Amendment of Solicitation

Solicitation No. 0900000369/SW0243

Amendment No. 3

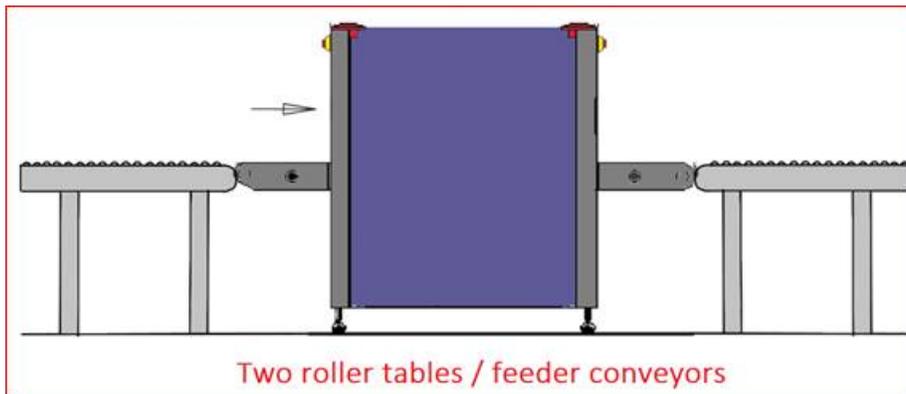
Question 7: In Price and Cost, Attachment A-REVISED (2), Line 11 (roller tables for 6040-2is) shows quantity 5, which seems to be one roller table per machine. Do you require a single roller table per unit to be installed on either side of the inspection tunnel, or two per unit for both entry and exit?

Question 8: In Price and Cost, Attachment A-REVISED (2), Line 21 (Feeder conveyor for 145180-2is) shows quantity 1. Do you require a single feeder conveyor for this unit to be installed on either side of the inspection tunnel, or two for both entry and exit?

Answer: Line 11 should be a quantity of 10, which is two (2) per unit, one (1) entry and (1) exit. Two roller tables/feeder conveyors per machine (as seen in the picture below). These changes have been completed and a revised form provided on the website. The new form is named Price and Cost, Attachment A-REVISED (3). Do not use the previously provided forms.

Answer: Line 21 should be a quantity of two (2), which is two (2) per unit, one (1) entry and one (1) exit. Two roller tables/feeder conveyors per machine (as seen in the picture below). These changes have been completed and a revised form attached on the website. The revised form is named Price and Cost, Attachment A-REVISED (3). Do not use the previously provided forms.
